# Staff Report for PLSUP-2605-0007

**Application Type:** Special Use Permit

**Location of Subject:** 507-511 W College St

Applicant is requesting a Special Use Permit to construct an electric power substation.

UMD 34kV/13.8kV STEP-DOWN SITE  
SITE DEVELOPMENT  
GRADING PLAN

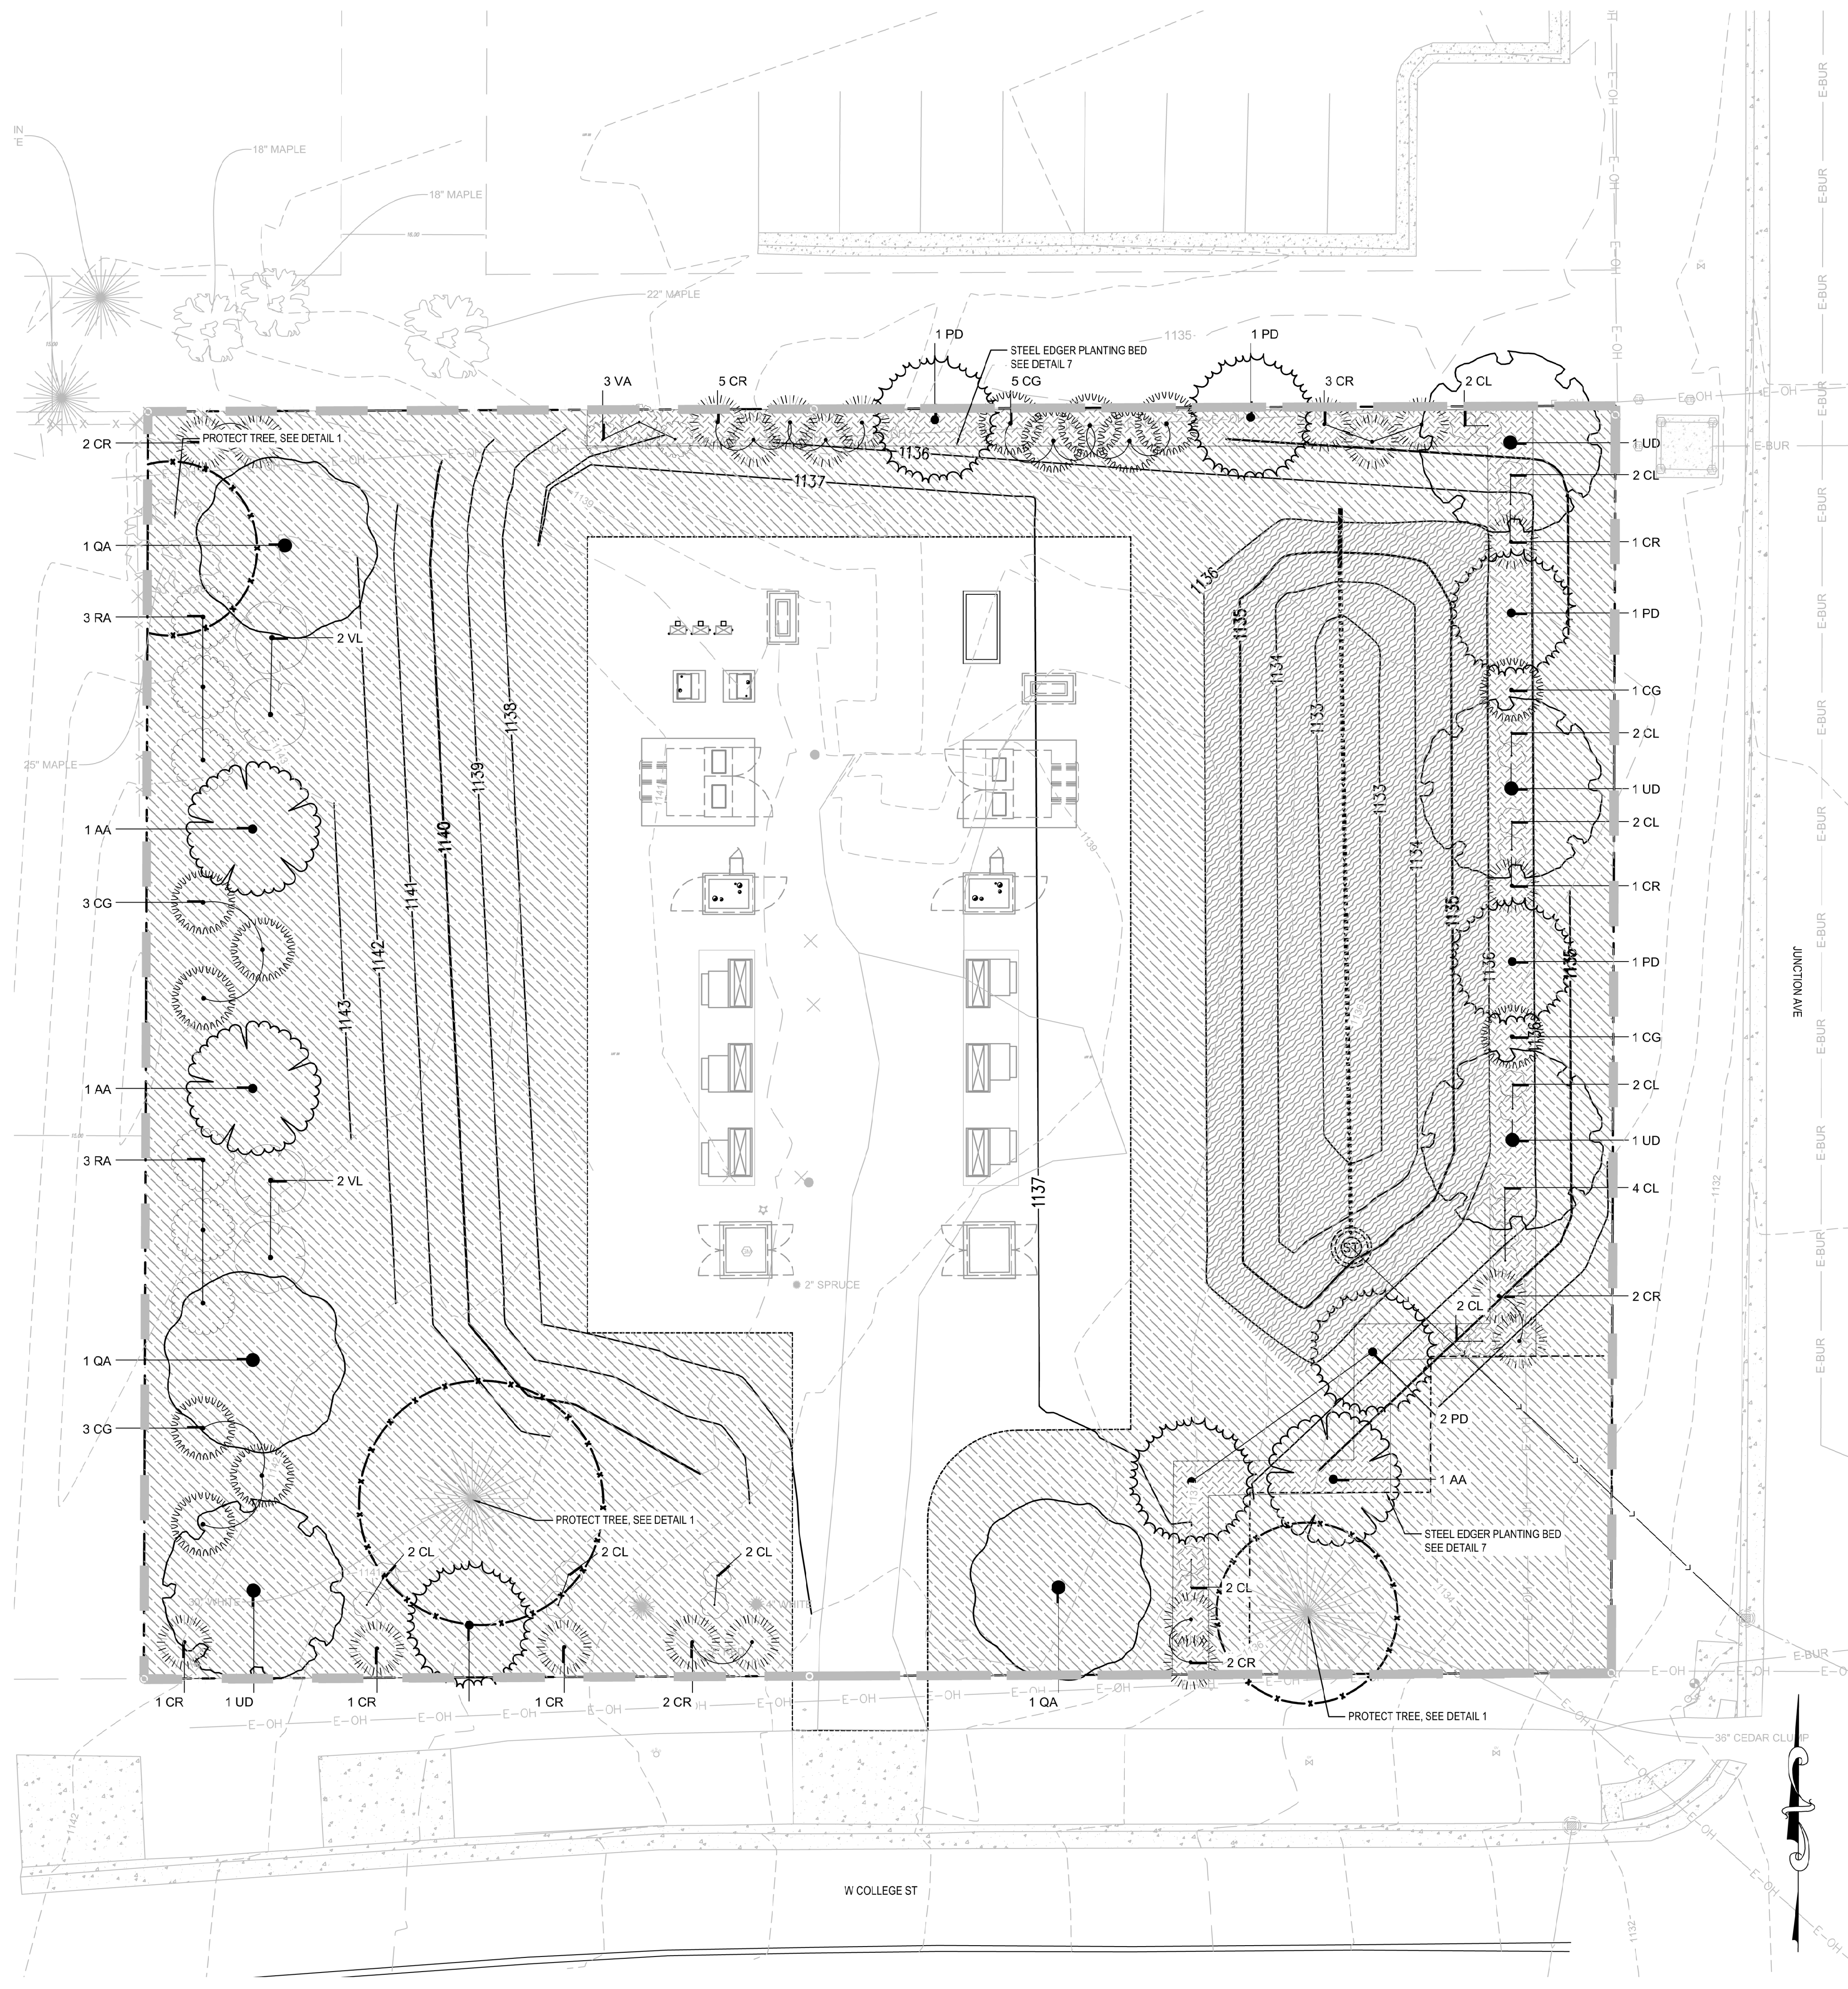
5. *Parking Standards (50-24.5)*: The proposed driving areas are depicted as gravel, which are not compliant. All driving surfaces must be finished in a dust free, hard surface material approved by the Land Use Supervisor.

1. The project must be constructed and limited to the plans submitted with the application.
2. No action by Planning Commission should be construed to provide approval for a sign by an off-premises user on this site.
3. Amended plans depicting all driving surfaces finished in a dust free, hard surface material must be submitted to and approved by the Land Use Supervisor prior to building permit approval.
4. Amended plans depicting at least 22 large shrubs along the west property line must be submitted to and approved by the Land Use Supervisor prior to building permit approval.
5. Amended plans depicting additional landscaping or fencing to screen the mechanical units or information demonstrating the proposed landscaping fully satisfies Sec 50-26.1.B.2 must be provided to the Land Use Supervisor prior to building permit approval.

UMD 34kv/13.8kv STEP-DOWN SITE  
SITE DEVELOPMENT  
LANDSCAPE PLAN  
SHEET 3 REV. 0C  
ME-36486-03

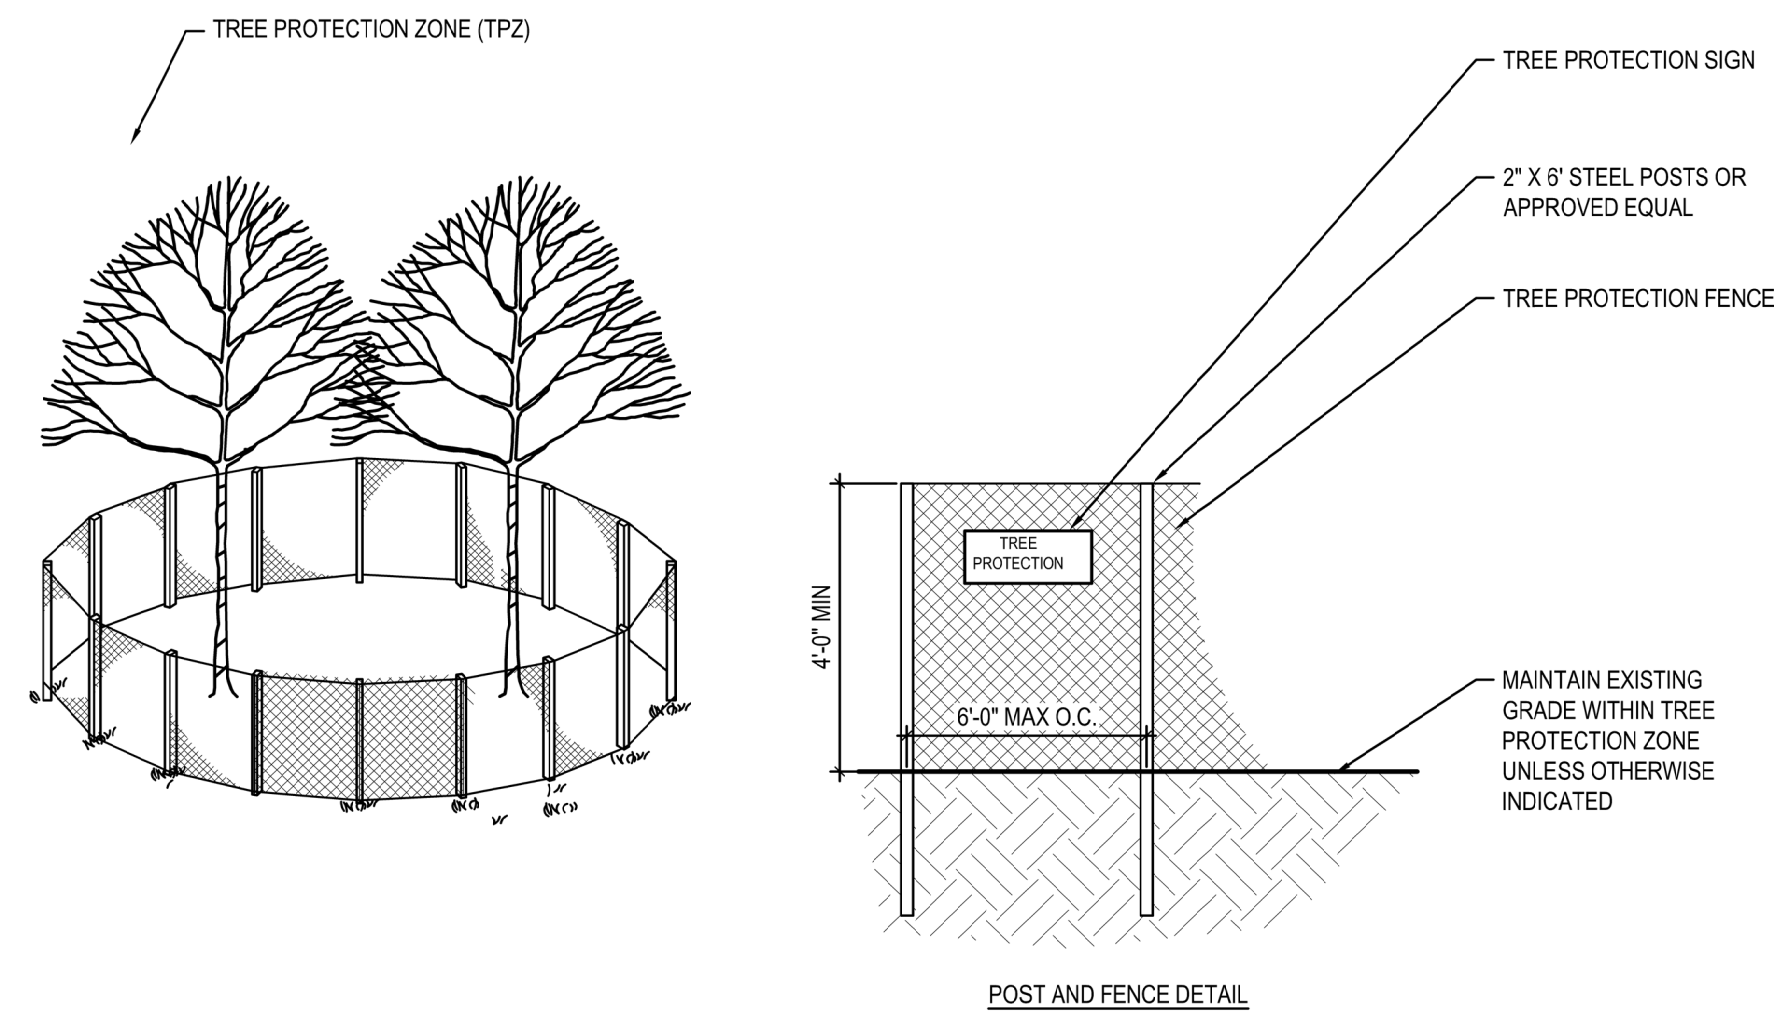
6. *Street Frontage Landscaping (50-25.3)*: Trees and shrubs meeting the code minimums have been proposed.
  7. *Landscaping Between Differing Land Uses (50-25.5)*: The applicant proposes to use landscaping to buffer between adjacent uses. All code required minimums have been met except that there are not enough large shrubs along the west property line. 22 large shrubs are required and 13 are depicted. Compliant site plans depicting at least 22 large shrubs along the west property line must be submitted to the Land Use Supervisor.

8. *Tree Preservation Requirements (50-25.9)*: Tree removals for this site do not exceed the threshold requiring replacement except for one white spruce, a special tree species, over 20" in DBH. This tree is centrally located within the site and proper protection of the tree and root system would prevent redevelopment. This impact is offset by proposed protection of several other mature trees on the site and planting of additional trees.

9. *Screening Ground Mounted Mechanicals (50-26.1.B.2)*: The landscaping requirements discussed in items 6 and 7 above also screen the mechanical units within the site. It is unclear if the landscaping, as proposed, will fully satisfy the mechanical screening requirements. The applicant must propose additional landscaping or fencing to screen the mechanical units or demonstrate the proposed landscaping fully satisfies Sec 50-26.1.B.2.
